# Assessment of Dam Safety Coal Combustion Surface Impoundments Draft Report

American Electric Power  
General James Gavin  
Power Plant  
Cheshire, Ohio

July 2, 2009

CHA Project No. 20085.4000.1510

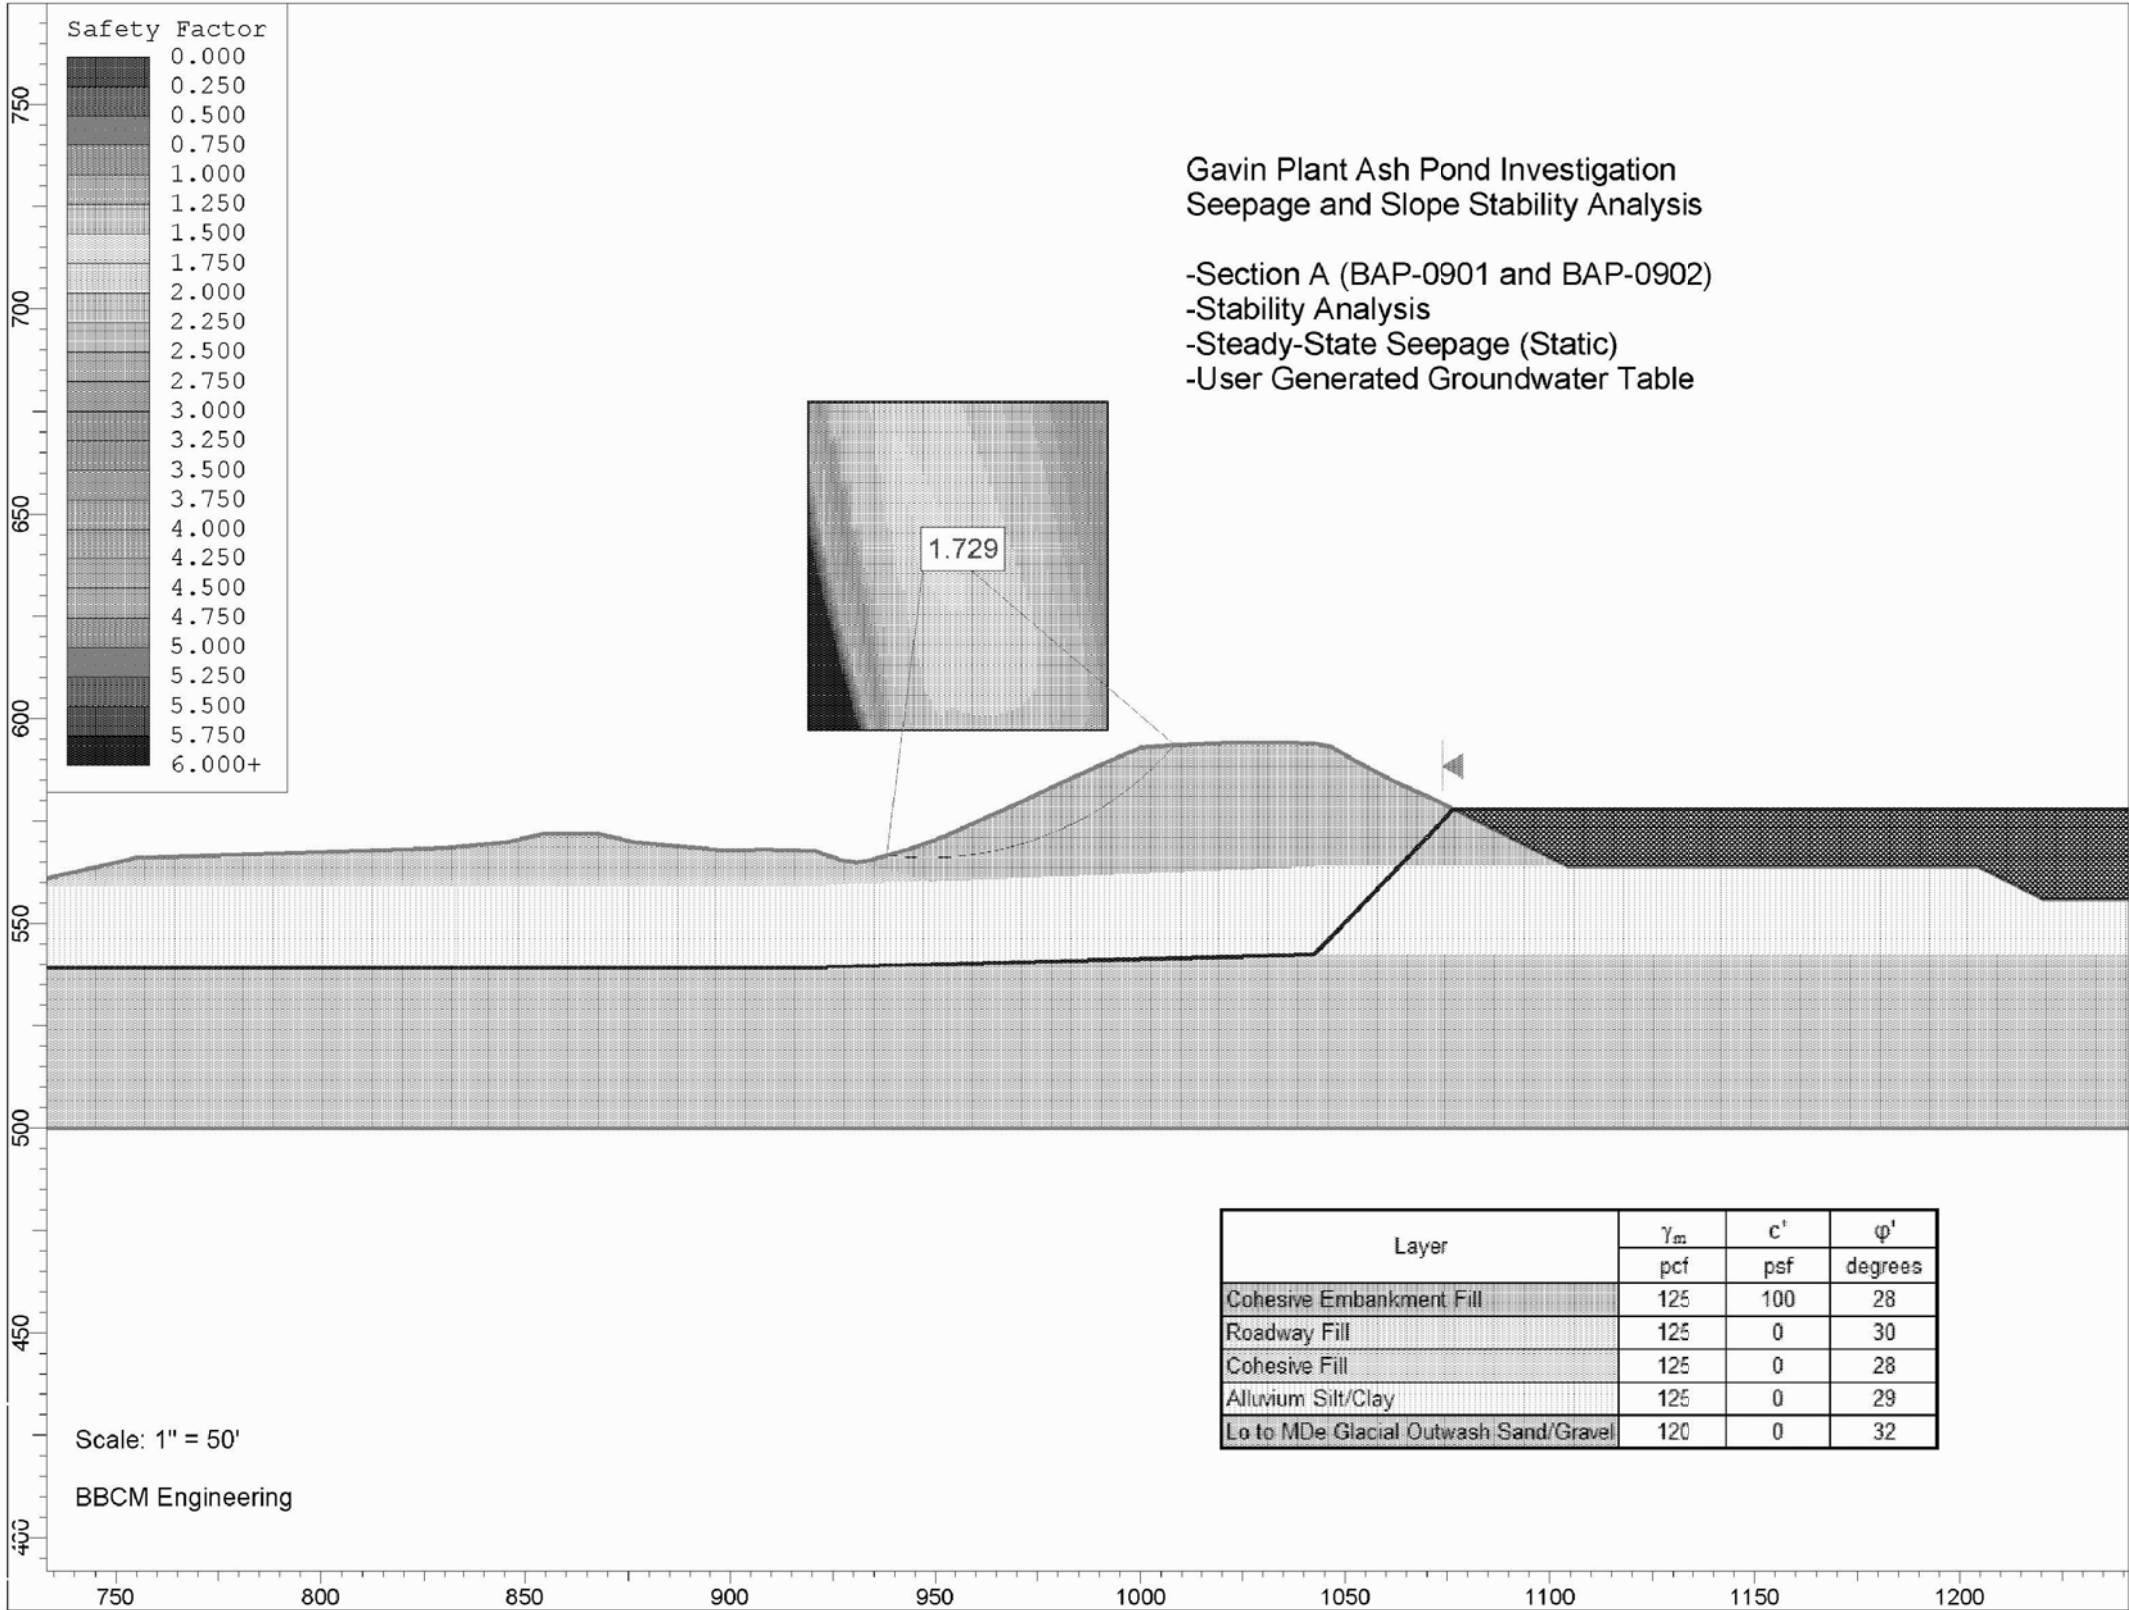
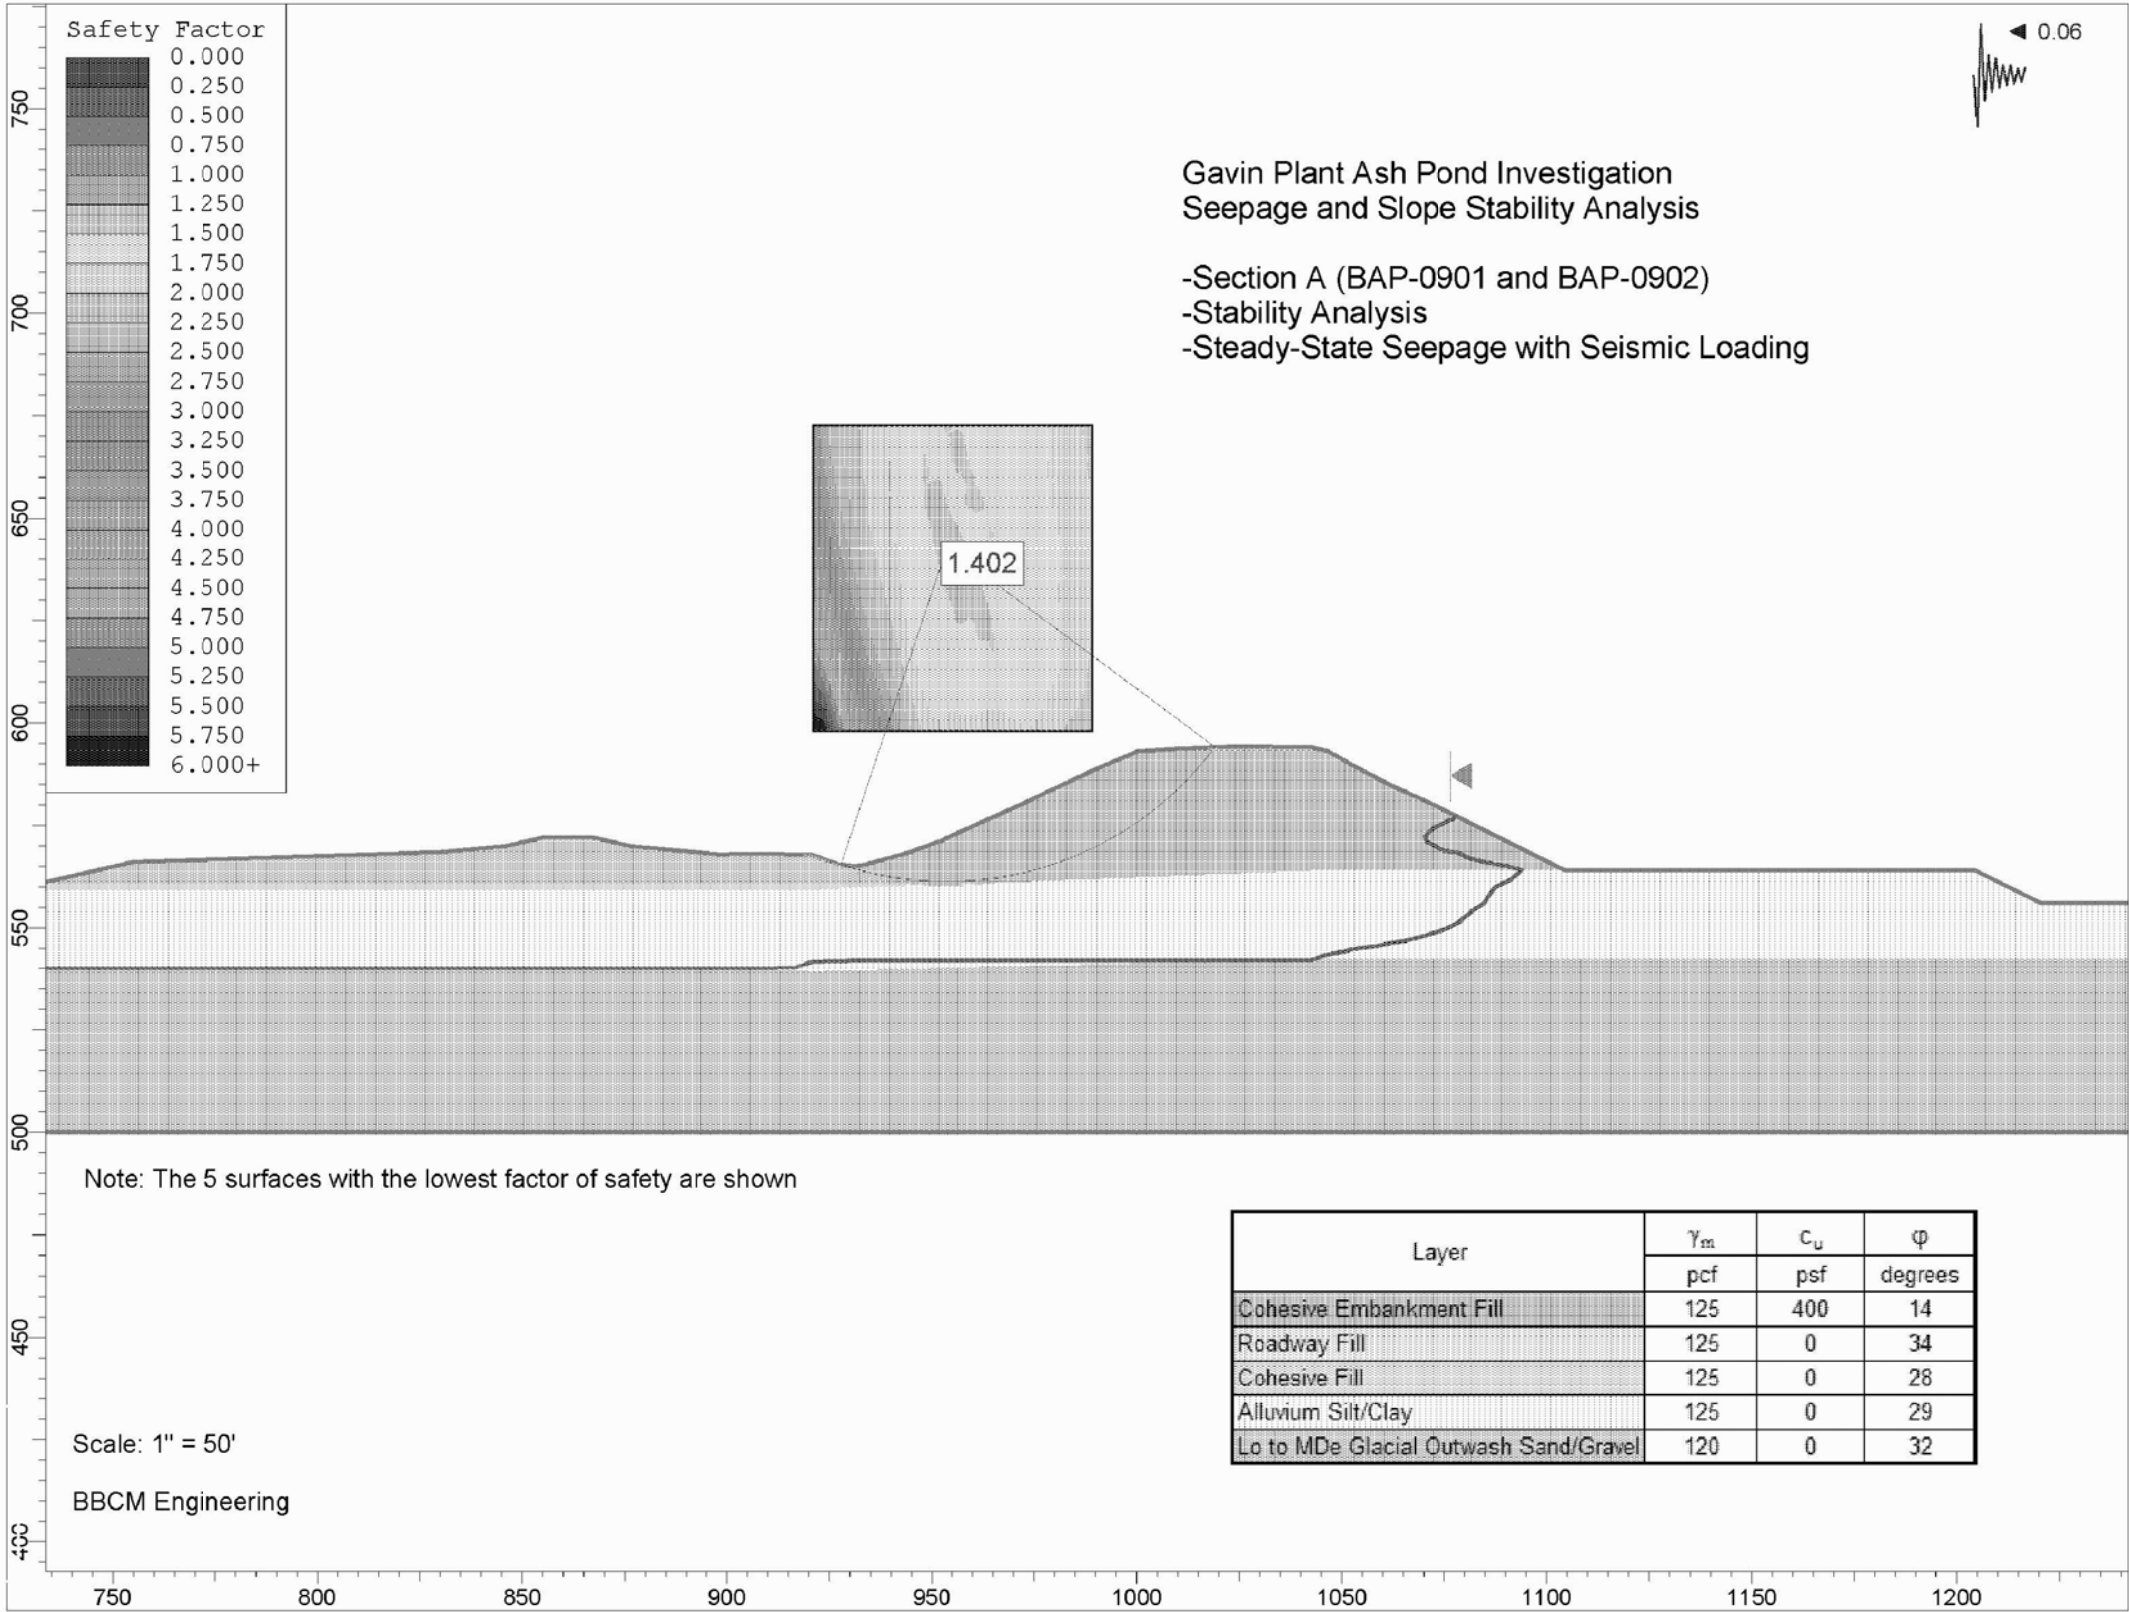
- The downstream slope stability outputs for the steady state load condition for Cross Sections A and B show failure planes within the embankment soils. If the alluvium silt/clay was modeled with a soft layer at the depth corresponding to the low sample effort the failure plain may actually fail within the alluvium foundation soils and not the embankment soils. We recommend that a model be prepared for this load case using the soil parameters for the soft alluvium layer described above.

- We recommend that an investigation be performed in which the properties of the alluvium silt/clay layer can be investigated in more detail in order to determine the presence and thickness of the soft layer of material indicated in the boring logs from June 2009. This scope of work should include laboratory testing of samples retrieved from the alluvium layer.
